CLINCH RIVER  
BREEDER REACTOR PROJECT

**PRELIMINARY  
SAFETY ANALYSIS  
REPORT**

PROJECT MANAGEMENT CORPORATION

Figure 490.38-3. Measured and Predicted Sodium Temperatures at Top of the Fuel Section, TX1016, for Row 2 FOTA-FFTF (Test Initiated from 100% Power/100% Flow)

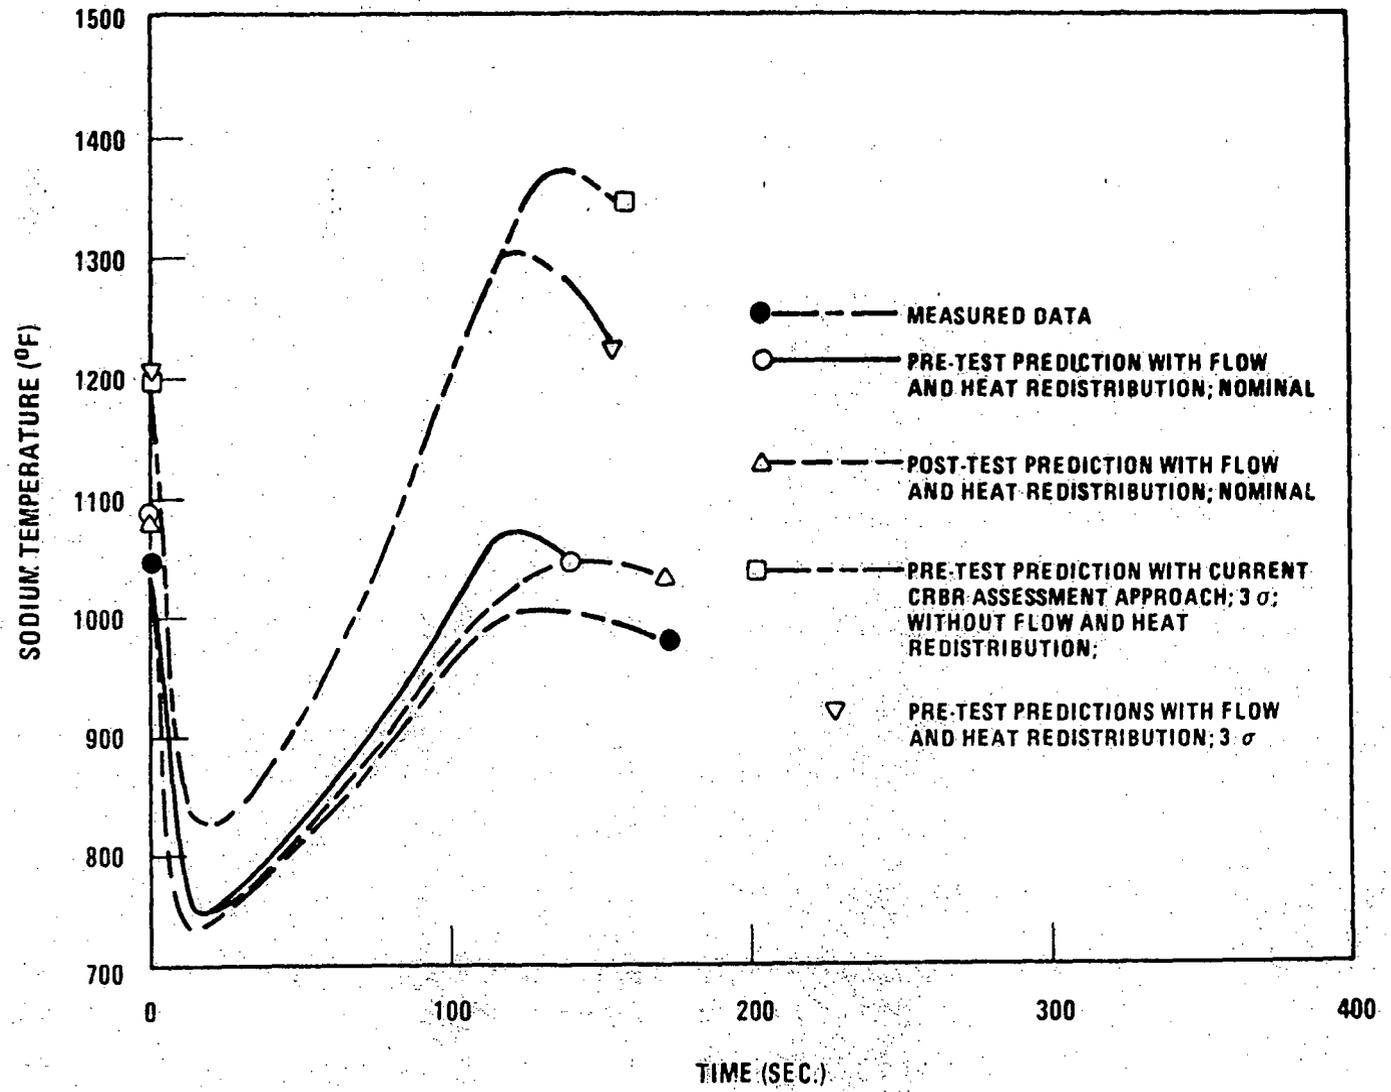
- o Figure QCS490.38-3 shows experimental data and results of analyses with DEMØ, CØBRA-WC and FØRE-2M for the highest temperature FFTF fuel rod during a prototypic natural circulation tests. This information was discussed at the January 26, 1982 NRC/CRBRP meeting. The top two curves of this figure show the effect of inter- and intra-assembly flow and heat redistribution reducing worst case temperature predictions such as those in WARD-D-0308. It can be noted that both of these predictions are extremely conservative (due to the uncertainty factors applied) relative to the experimental test data and expected predictions (nominal) given by the low curves on the figure.

Figure 490.39-1. Maximum Cladding Temperature ( $3\sigma$ ) for FA-52 as Calculated With and Without Transient Gap Conductance Variation (Loss of Off-Site Electrical Power Undercooling Transient)

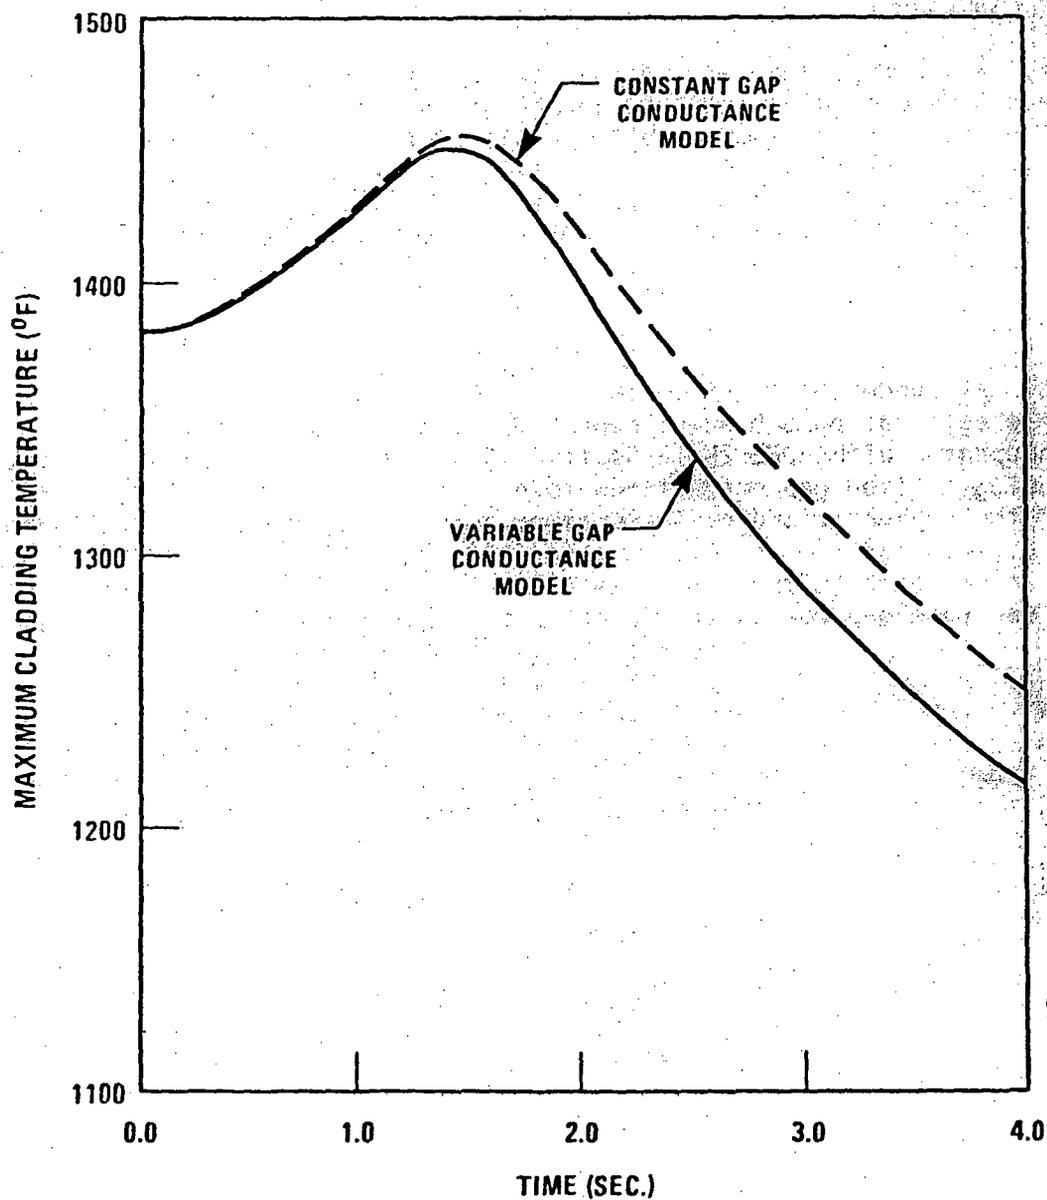
The worst case undercooling transient of PSAR Section 15.3 is the "loss of off-site electrical power" event reported in Section 15.3.1-1. This transient has been updated with FØRE-2M in Section 15.1.4 for the heterogeneous core design using a fixed gap conductance model. For fuel assembly #52 which contains the highest cladding temperature hot rod for any core location at any time in life, a maximum cladding temperature of 1455°F was calculated in a 36 basis. In response to the above question, this analysis was repeated with the FØRE-2M variable gap conductance model (both the Section 15.1.4 update and this new evaluation having the same initial gap conductance at time zero). Because of the mechanisms described in Section 4.4.2.8.5 and referred to in the question, a 5°F decrease in maximum cladding temperature was found due to the lowering of the gap conductance from its initial value as the cladding expands proportionately more than the fuel. A comparison of the maximum cladding temperatures for the two cases is given by Figure 490.39-1.
